REMARKS

I. PRELIMINARY REMARKS

FIG. 4

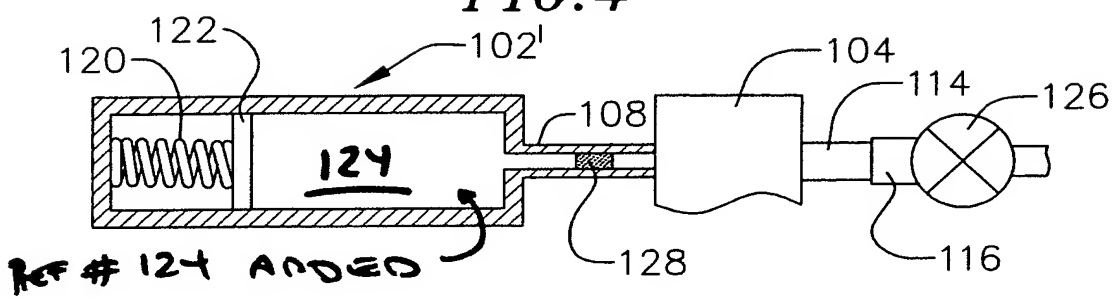
Applicant respectfully submits that the objection to the drawings has been obviated by the addition of reference numeral "124" to Figure 4.
